Ballater & Crathie Community Council (BCCC)

December 2015 Ballater Flood

Flood Information Group
December 2015 Ballater Flood
Report 1 Causes, Mechanism & Uncertainties

Figure 3: Map prepared just after the flood to show Ballater flow mechanisms & flooding

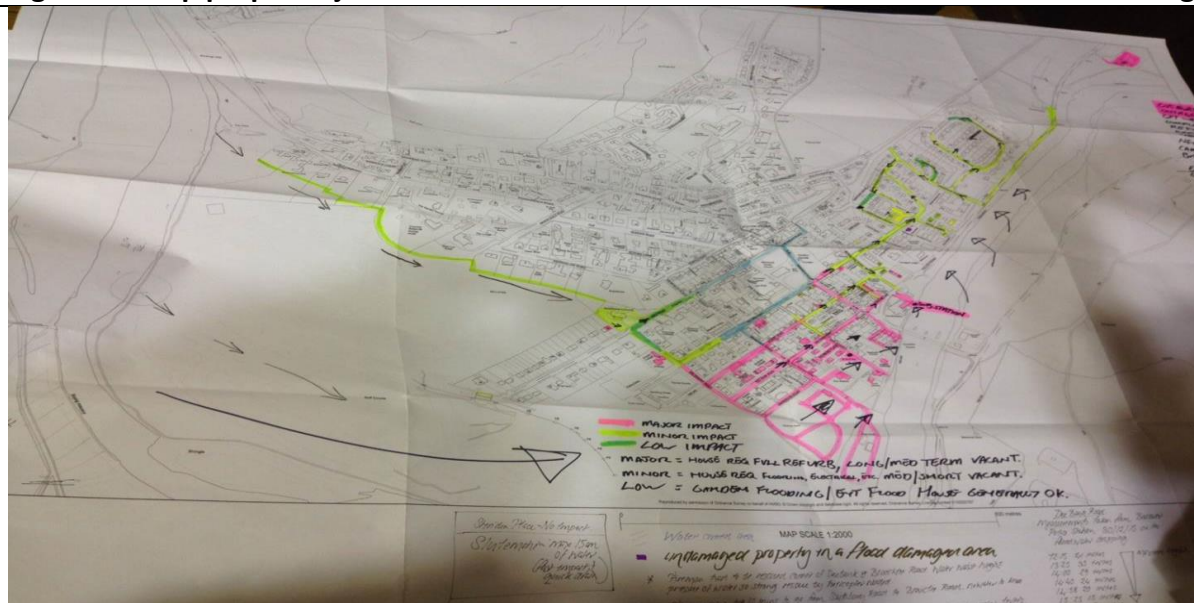
- SEPA provided a photograph (Figure 3) of a map annotated by AC, showing the reported flow mechanisms & identifying the areas affected by flooding.
- The map shows 3 areas of river flooding upstream of the Bridge:

- Fig 3 also indicates the route of the major flood incursion from the Red Braes, going directly towards the caravan site, which supports the terrible damage inflicted there.

“The location of the breach in the informal flood defence embankment during the December 2015 flood event was identified by AC” & is indicated in Figure 4 below. The breach location in Figure 4 (Red) identified by AC to RPS is not consistent with the major breach in SEPA’s map (Figure 3). Figure 4 shows the breach occurred near 13th Green, which Figure 3 suggests was a lesser breach in comparison to the multiple breaches downstream. (see 4.5)

Figure 5: Breaches opposite & downstream of Red Braes: plus 13th Green

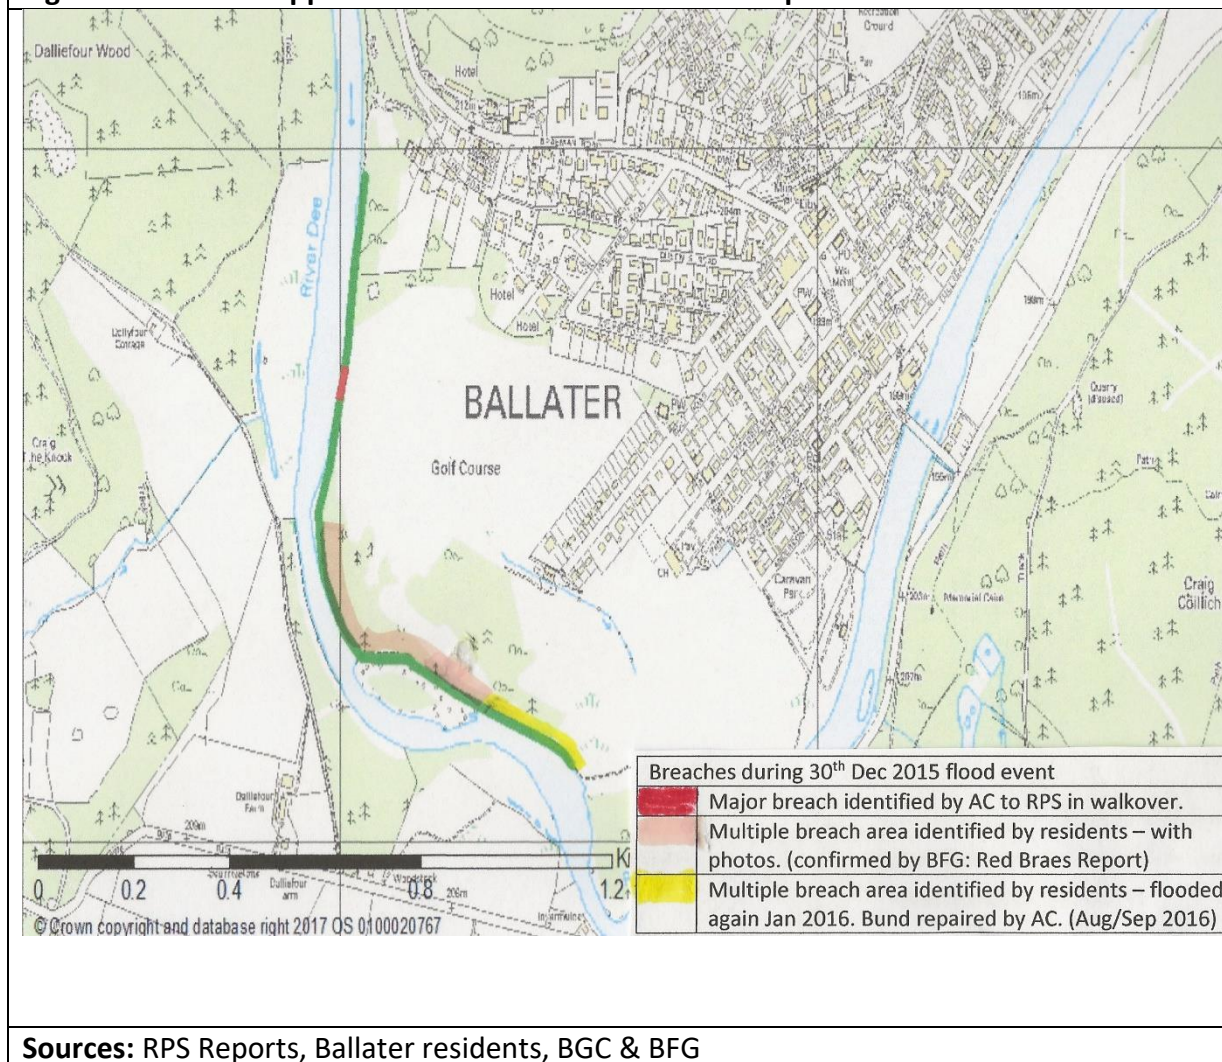
- That there was a breach in the area of 13th green, & its scale 35m wide, is agreed by AC, RPS, BFG and others who have studied the flood or observed the resulting damage. All parties also agree this breach was not caused by the collapse of the Red Braes. (Figs. 4 & 5: Red)

- As indicated in 4.5, and confirmed by photographs, there were additional major breaches opposite and south of the Red Braes. These breaches were in total length estimated to be 100-150 metres, & combined with the overtopping (see 4.5), would explain fully the deluge of water which increased water level and flow rate in the village very rapidly. The areas of these breaches are marked in brown & yellow on Figure 5. – though it is not suggested that this was one continuous breach.

- From Figure 5 it is clear that in the yellow area the river is turning and flowing towards the bund. A breach of the bund in this area is therefore likely to be far more damaging as the river is flowing directly into the breach – rather than where the river is flowing parallel to a breach. (e.g. 13th Tee)

- The short width of the breach at 13th Green suggests this was not the major breach and the narrow width would not support the rapid increase in flow rate & flood depth.

Figure 6: Flood Depth Map 30 December 2015 Historic Event

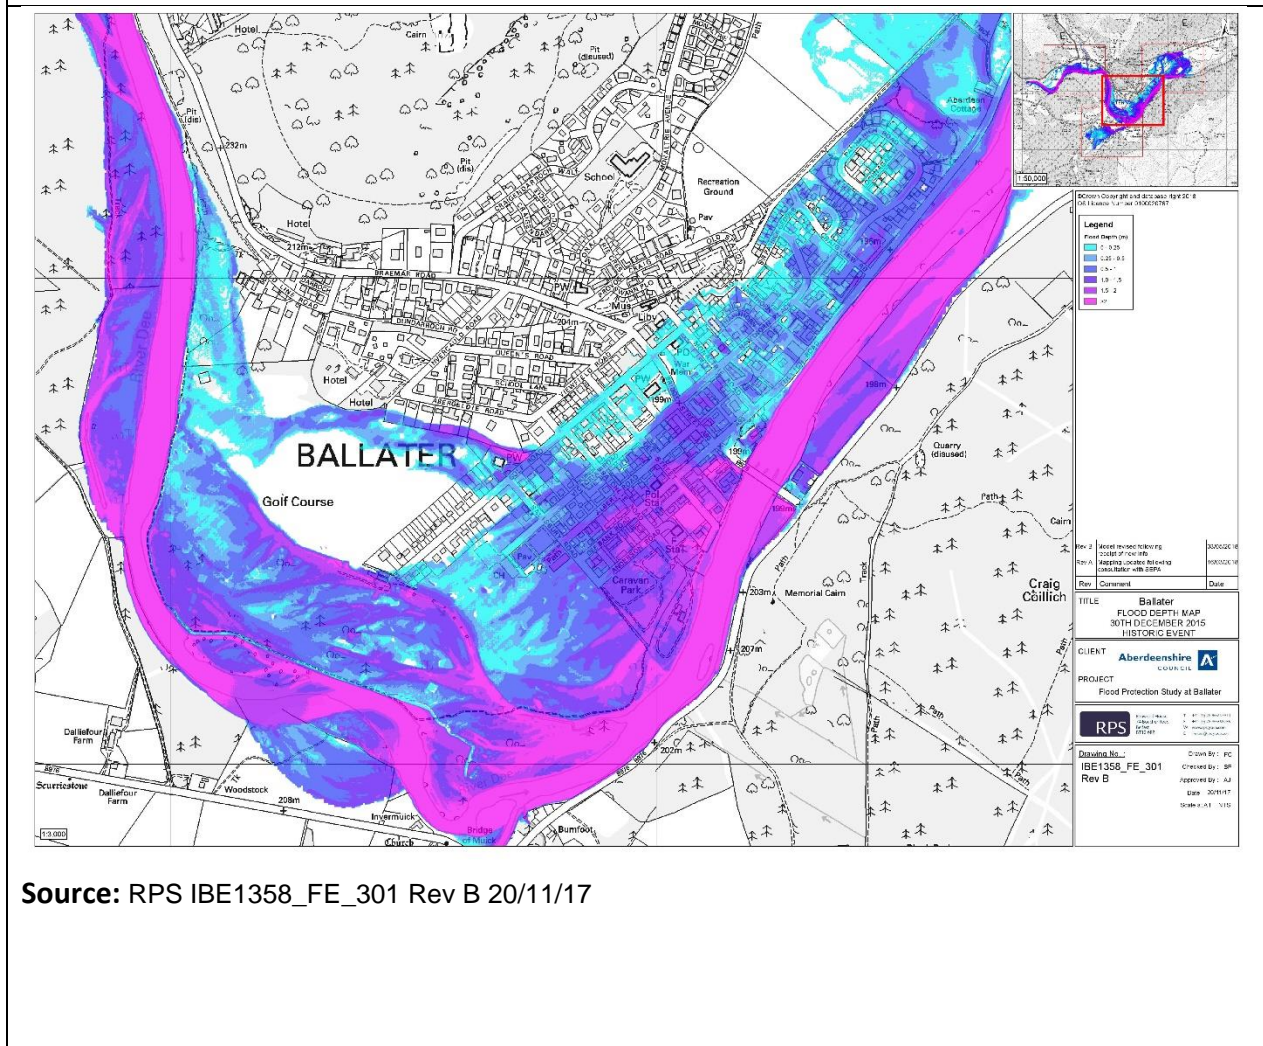
- In the caravan park & Dee St area, flood water levels exceeded 2metres. Flood water arrived both from the Dee overtopping at Dee St & the BGC, but the force and direction of the flow was from BGC. This flood water was at a similar level to the river water, the body of water becoming one whole. Therefore, the river appears to have overtopped by more than 2 metres in places. (See Figure 6)

Photo 7: Taken (at 10:25am 30th Dec15) from downstream, north side of Dee. River flows increased by 50% from this point. Caravan debris visible upstream on the nearest abutment.

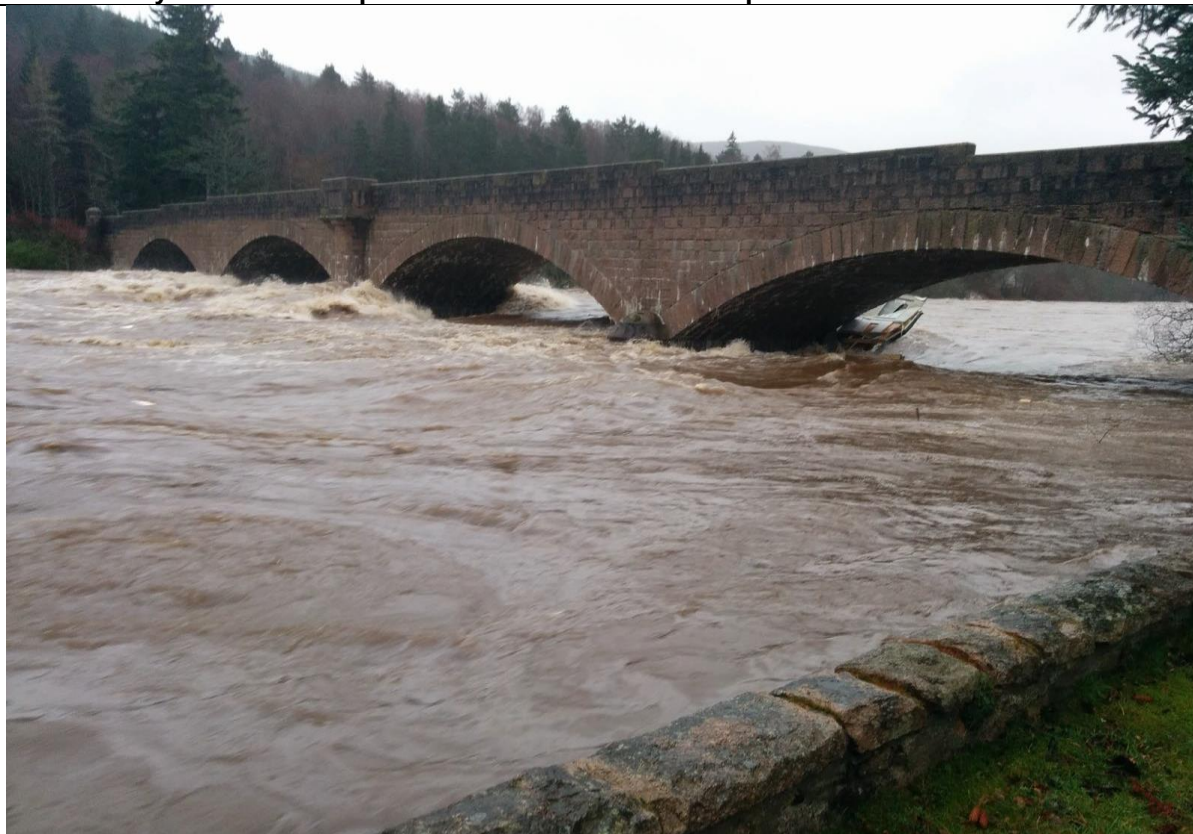
- The photos suggest the bypass is much greater than 5%, as the 2015 photos show the water level at The Bridge not dissimilar to 2014 flood – even though the peak flow in 2015 was double that of 2014.

- A further serious risk arises as raised water levels increase the risk of obstructions. This is seen in Photo 9, with caravan debris restricting flow & The Bridge capacity.
